APPLICATION NO.	FILING DATE	FIRST NAMED INVENTOR	ATTORNEY DOCKET NO.	CONFIRMATION NO.
10/082,466	02/25/2002	Tetsuya Okumura	57090 (70904)	4306
21874	7590	09/12/2007	EXAMINER	
EDWARDS ANGELL PALMER & DODGE LLP			PSITOS, ARISTOTELIS M	
P.O. BOX 55874			ART UNIT	PAPER NUMBER
BOSTON, MA 02205			2627	
			MAIL DATE	DELIVERY MODE
			09/12/2007	PAPER

Office Action Summary	Application No.	Applicant(s)
	10/082,466	OKUMURA ET AL.
	Examiner	Art Unit
	Aristotelis M. Psitos	2627

DETAILED ACTION

FIG. 2

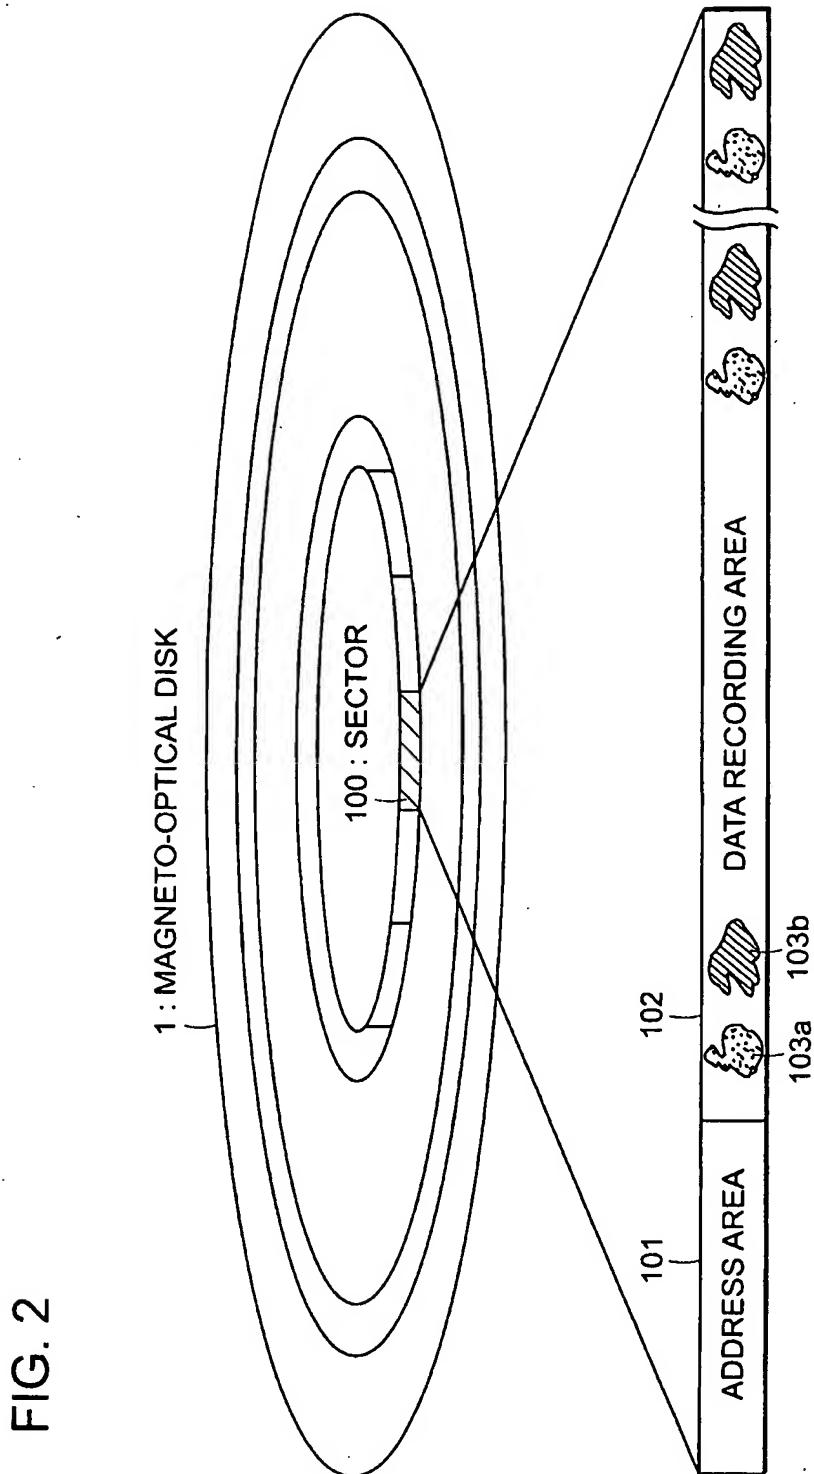
The new drawing has been entered.

Okay to enter 8
